Temperature Screening MinMoe Terminal
Release Notes (2021-02-08)

| Device Model: DS-K1T671TM-3XF DS-K1TA70MI-T	Firmware Version	**ARM**：ACS_671_3XF_AI3_EN_STD_V3.2.2_build210207 　　　　ACS_671_3XF_AI3_EN_NEU_V3.2.2_build210207 **MCU**：ACS_DS-K1T671_ST1_GML_GM_V1.0.1_build210123 **Thermal Module**：digicap_thermo-en-gm_V5.5.4_build201107
	SDK	Latest baseline
	iVMS-4200 Version	Latest baseline

Reason of Upgrade
Add new features, fix bugs, enhance products quality and meet customers' requirements.

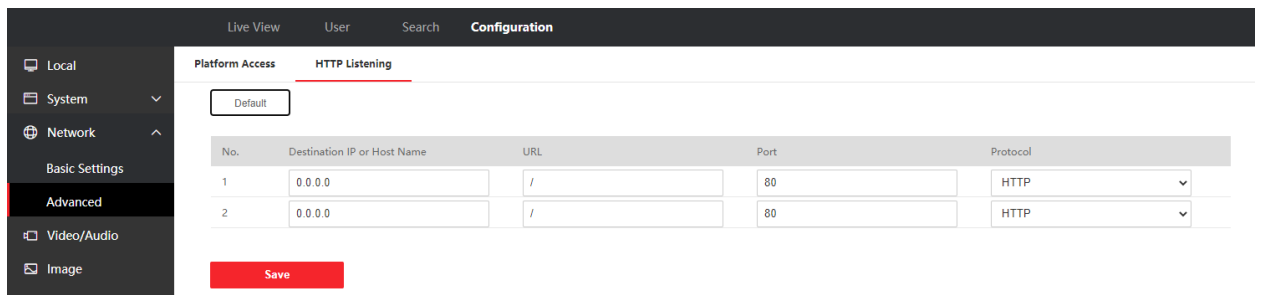
New Feature
1. Support web interface to login and configure device from browser.

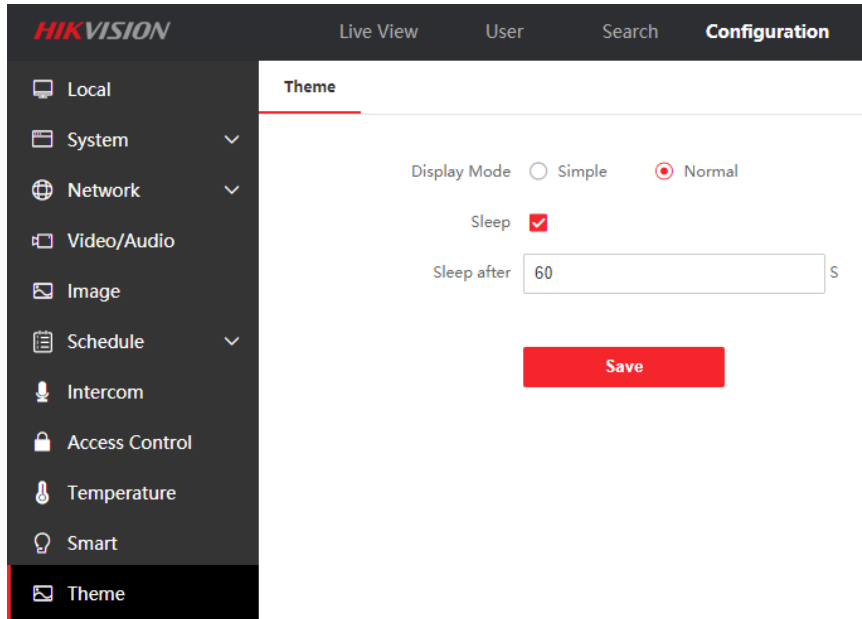
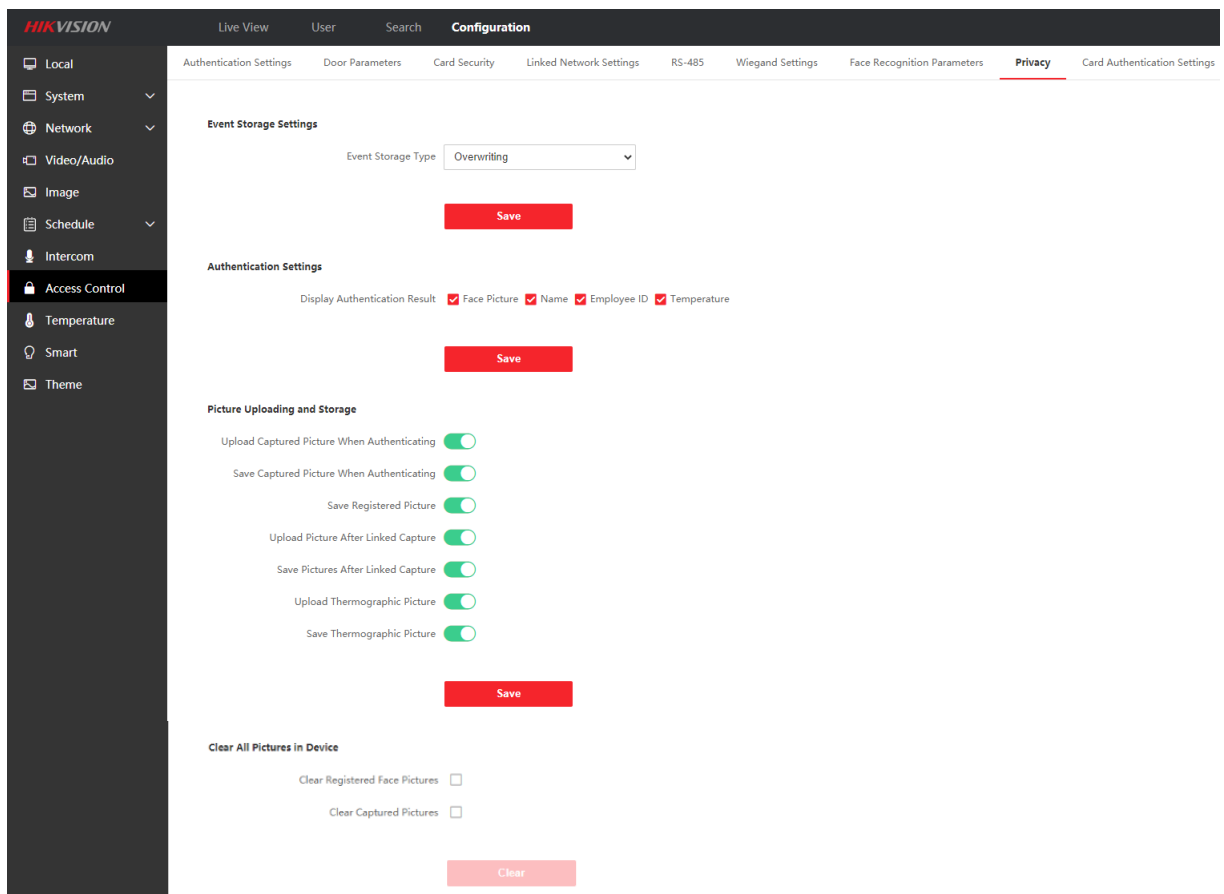
2. Support TTS (English only) self-defined audio prompt for verification (disabled in default).

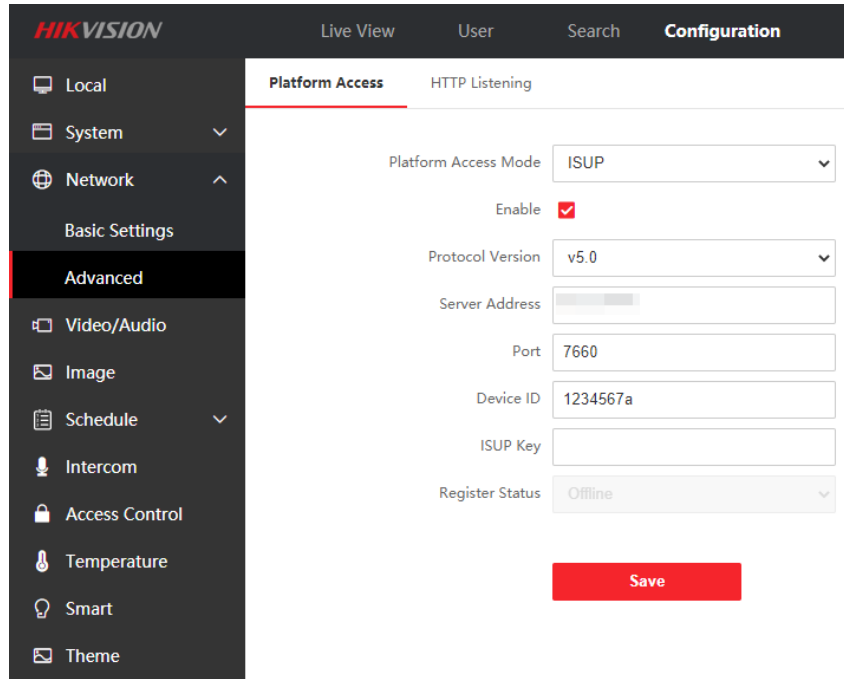
3. Add device operation log query function

4. Add ISAPI event monitoring upload (HTTP/HTTPS listening) function for integration

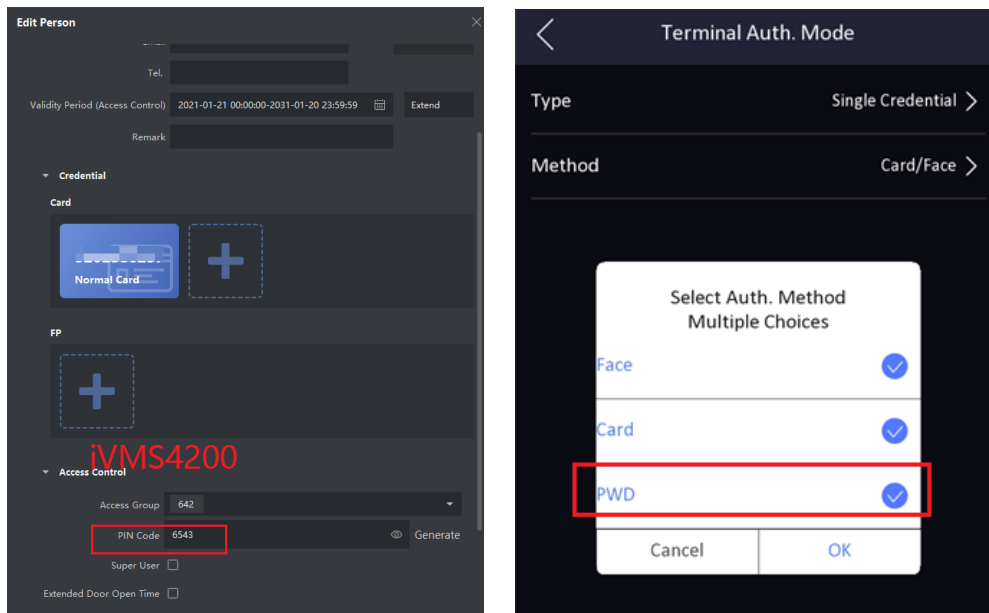
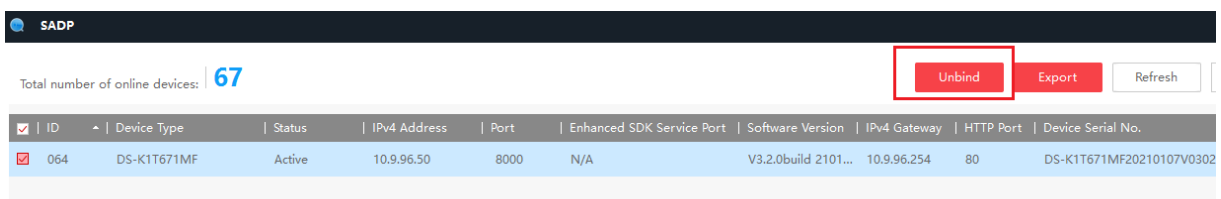
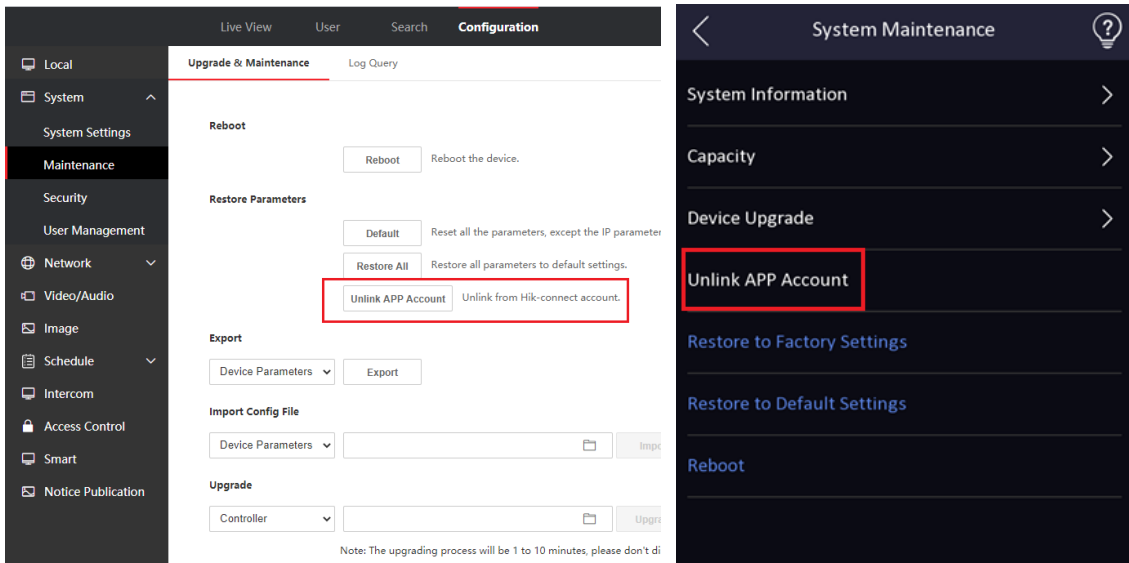
5. Add simple mode (disabled in default), after enable, it will not display live view when verify face

6. Add privacy protection, customer can define the privacy related parameter, such as whether to display photo, name, ID number, temperature after verification, Event Storage Settings, Picture Uploading and Storage, Clear All Pictures in Device

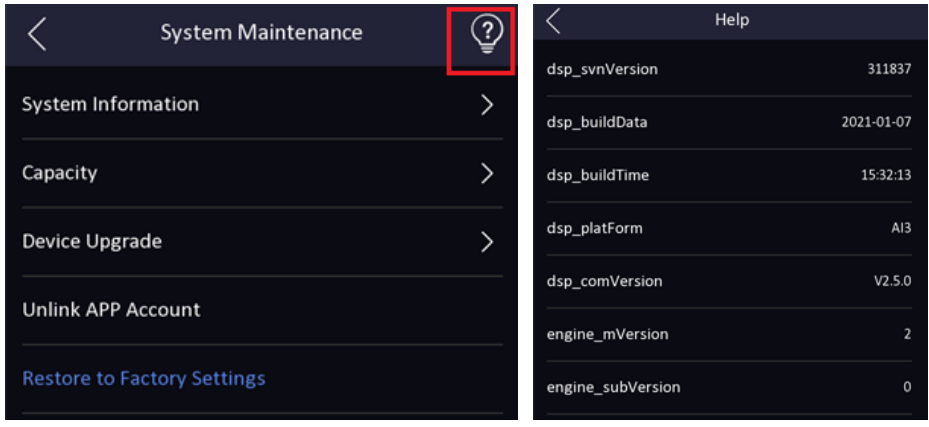
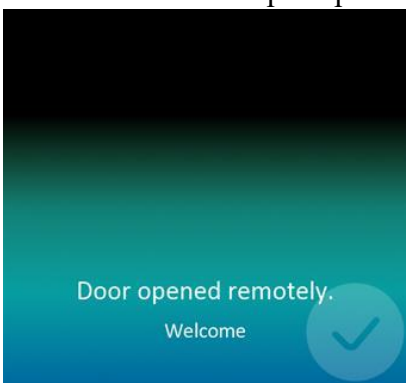
8. Support PIN code only to open the door (disabled in default)

Note：PIN code should be configured from software, iVMS4200 already support, HikCentral Pro will support PIN code configuration in V2.1 expected to be released in June

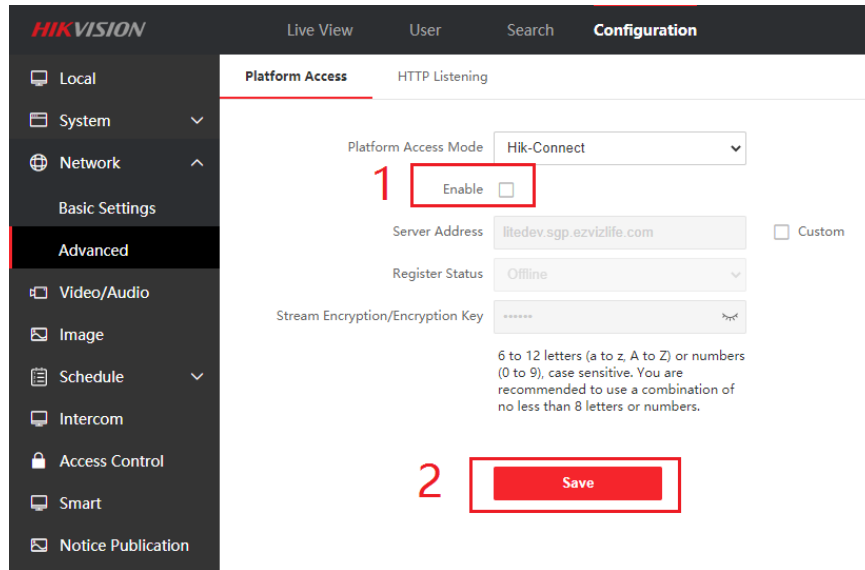
9. Support unbind device with hik-connect account on SADP tool, local UI and web

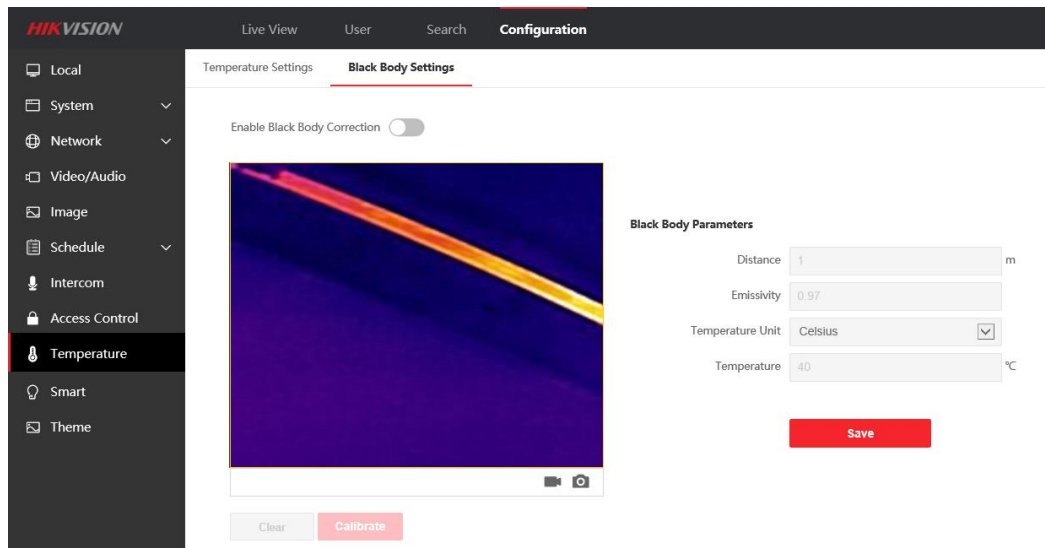
10. Add help interface to check module version for technical support (long press for 3s)

11. Add audio prompt 'The door is open' when open door on iVMS4200, HikCentral Pro, Hik-Connect App, and device UI will show prompt
